AI/230817 / LLFA Letter / SCP Response  
24 February 2025

Planning Reference – 139751/FO/2024

**SCP Technical Response to Manchester City Council Planning Condition [PC27] Drainage**

| Drawing No. | 200509-0500-002 | Rev.                 | B          |

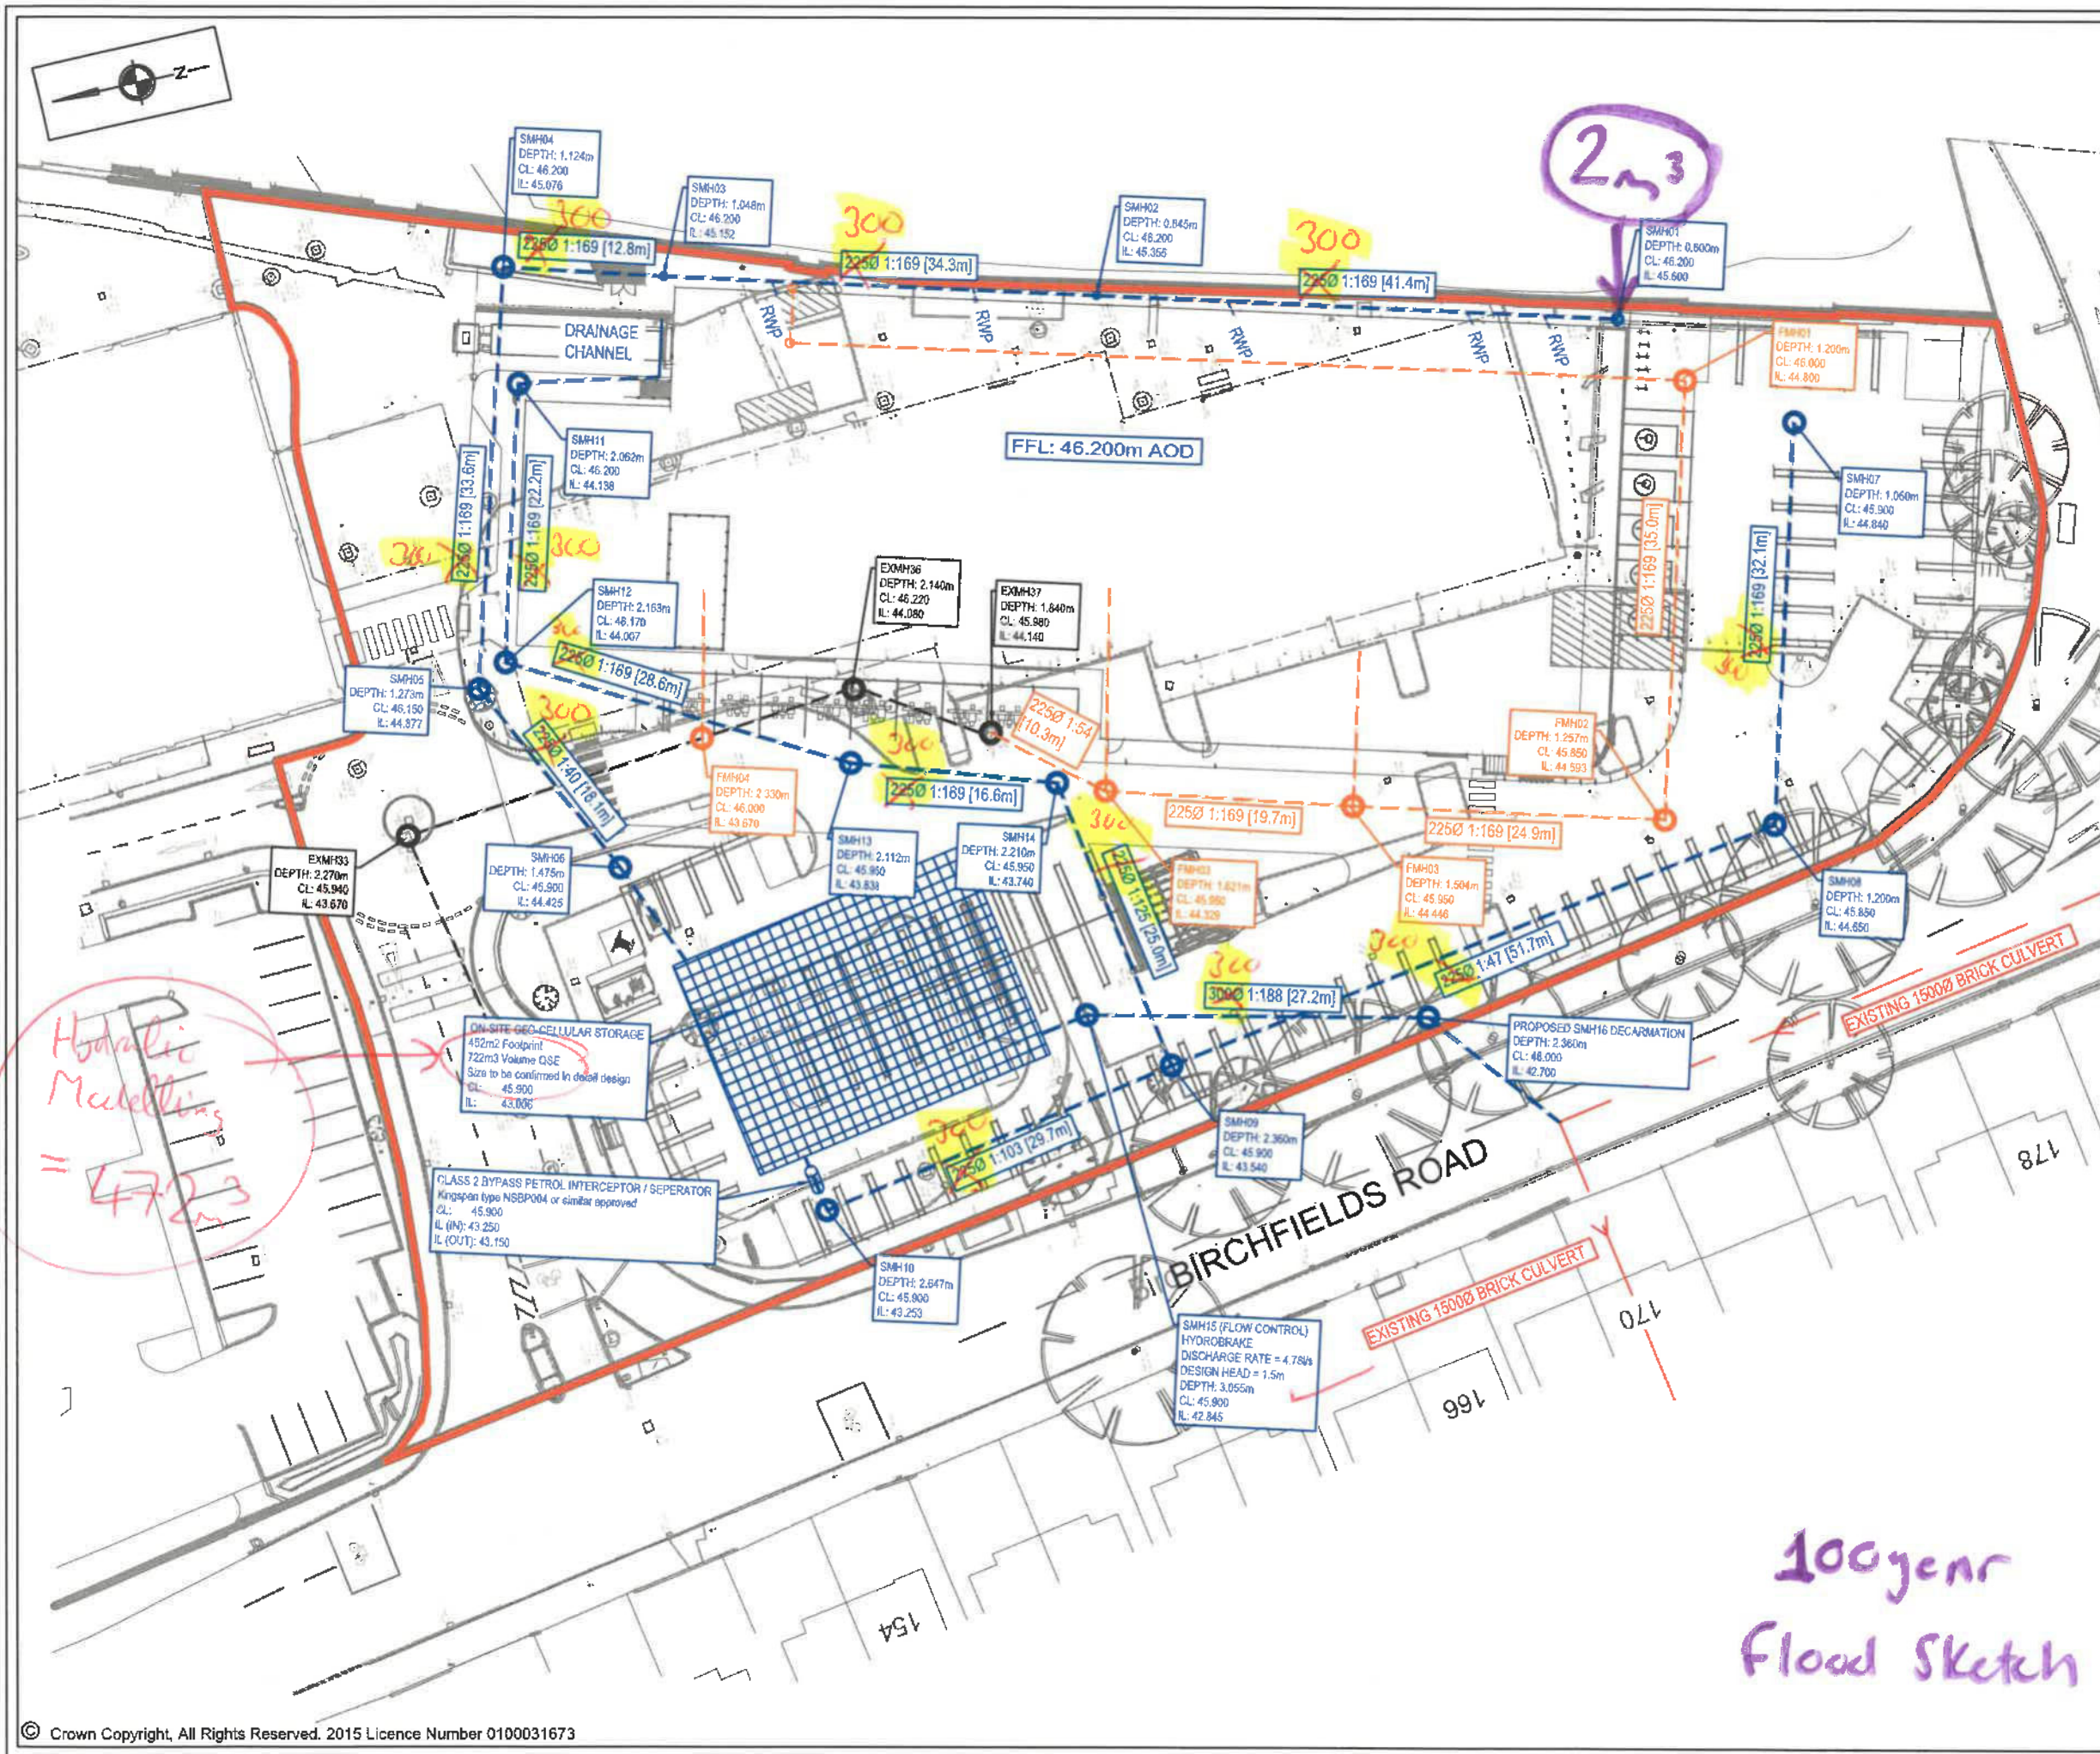
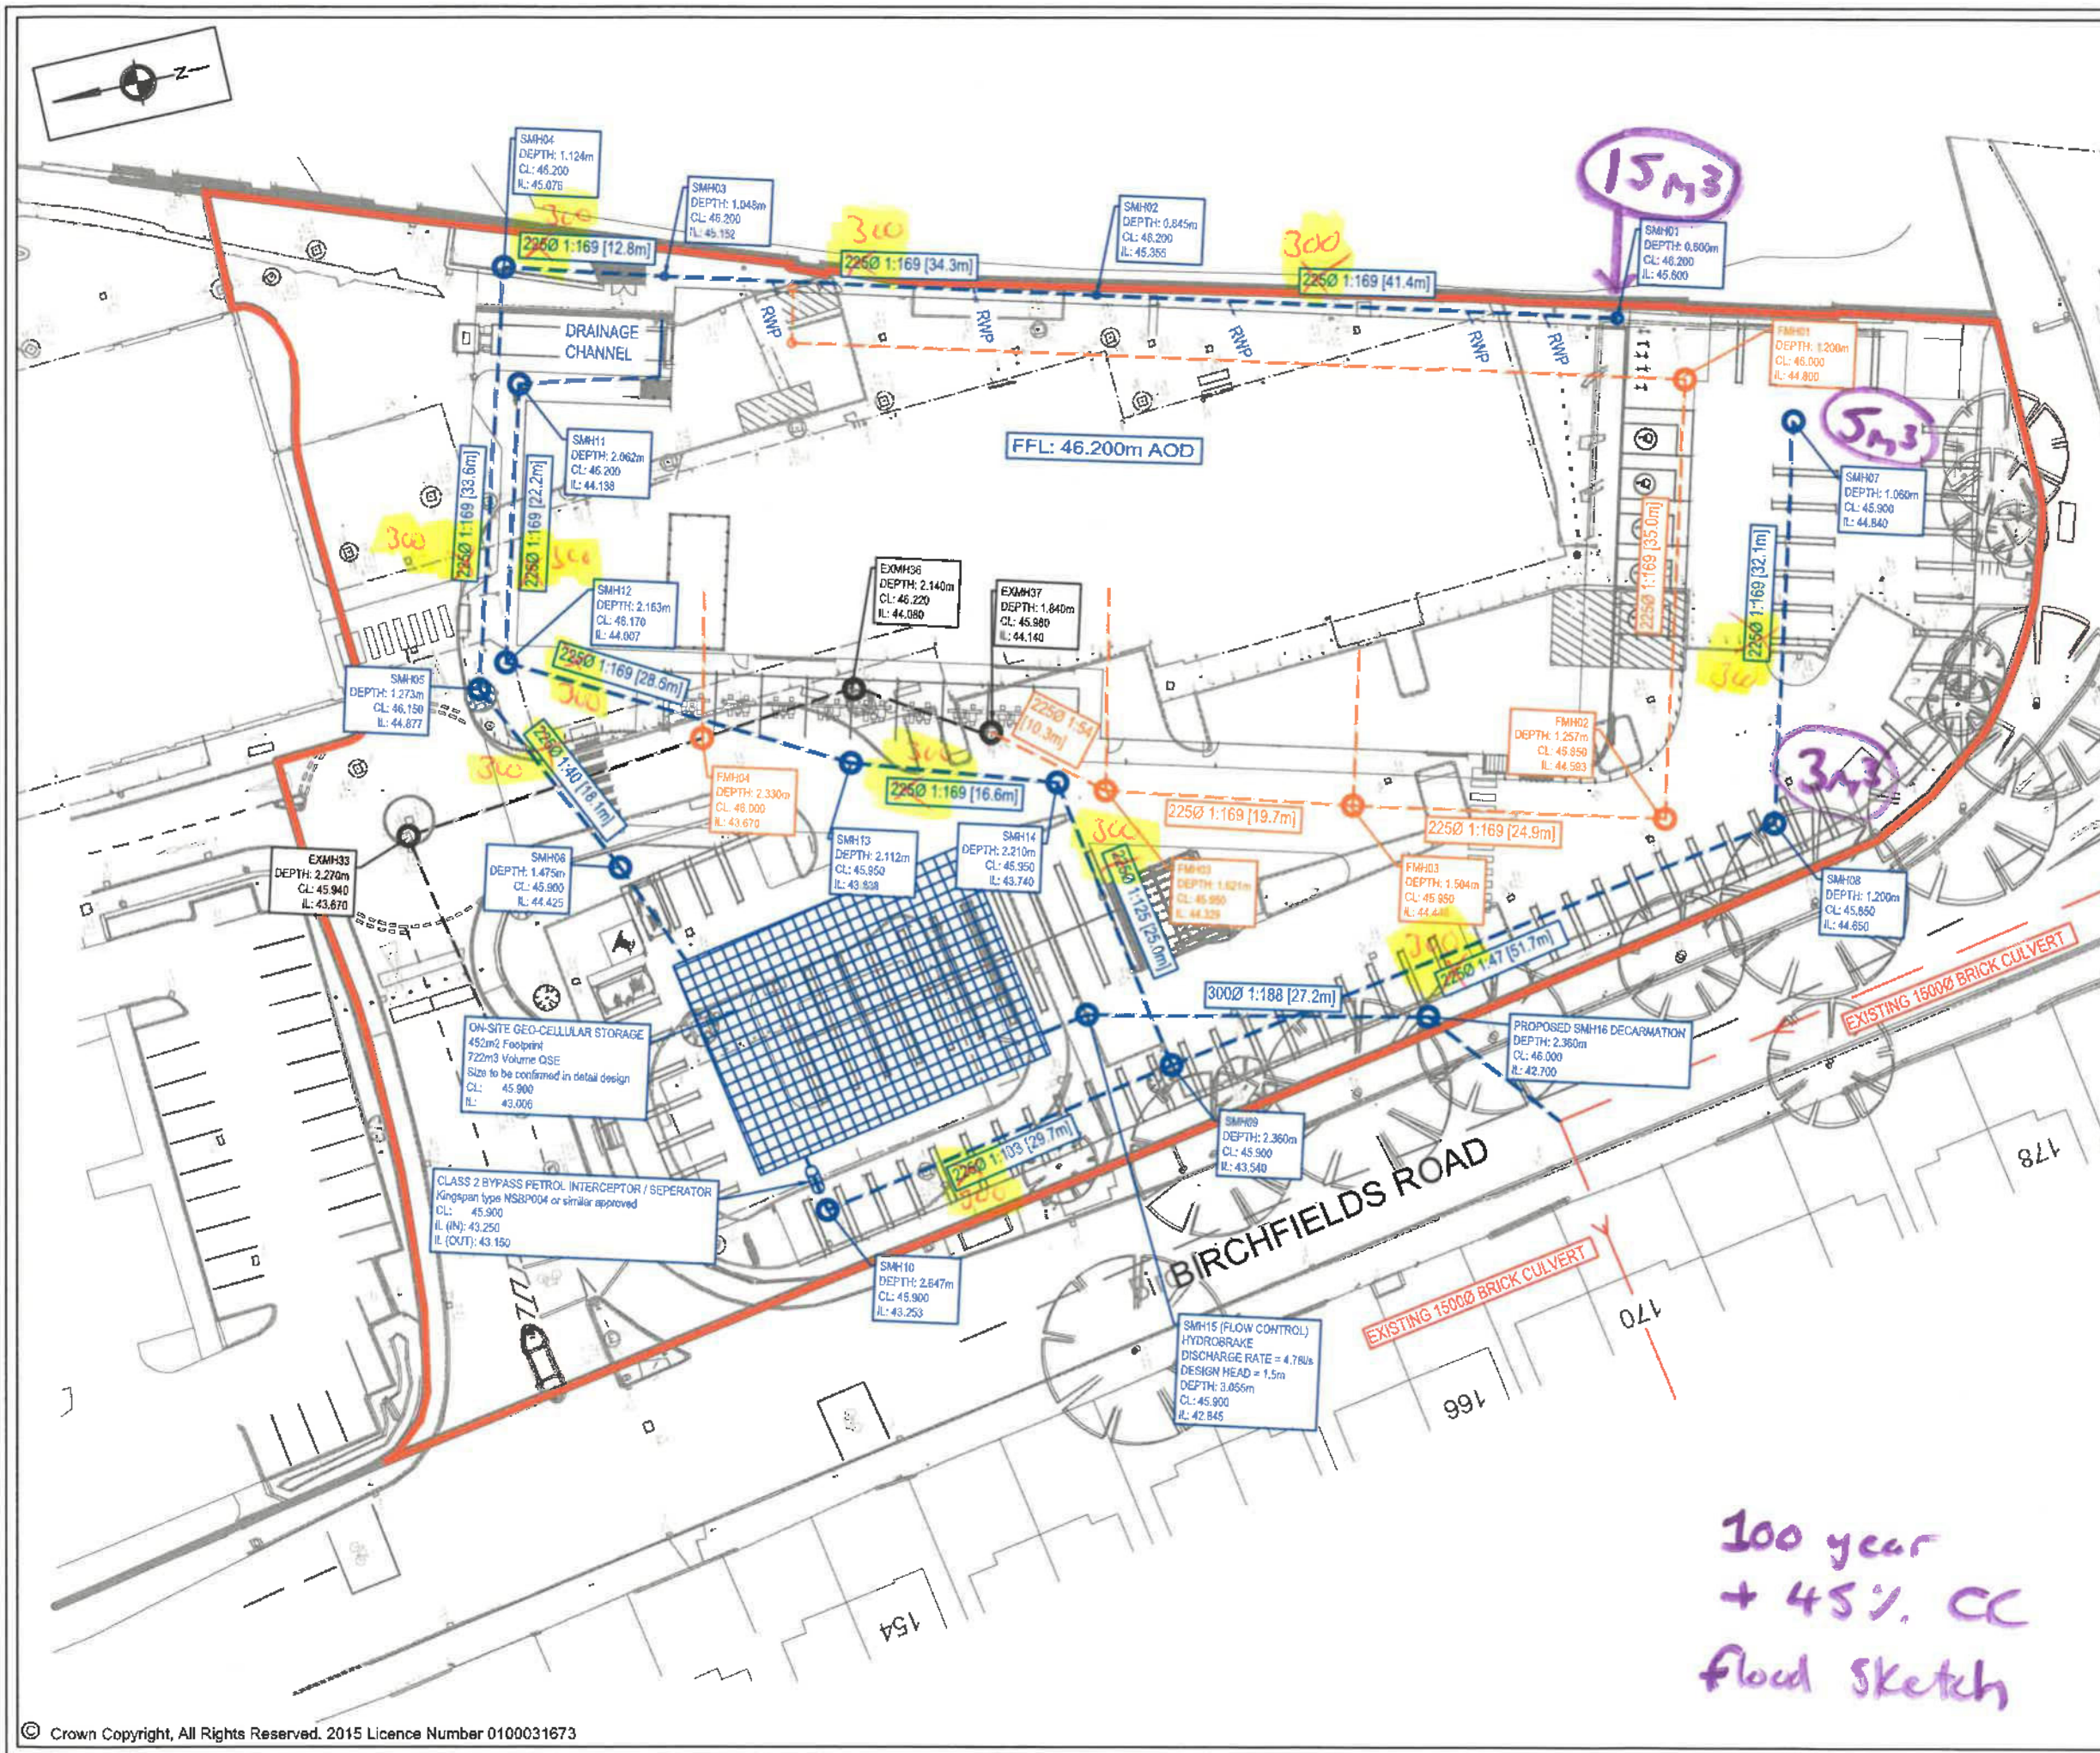
| 12 | For sites where proposed development would cause unusual pollution risk to surface water (large car park areas (>50 parking spaces) or industrial estates), evidence of pollution control measures (preferably through SuDS) is required                                                                                                                            | Petrol interceptor is proposed as a SuDS measure to minimise pollution risk caused by the vehicles. Refer to the Drainage Strategy 200509-0500-002 Rev B                                                                                                                                                                                                                                                                                           |
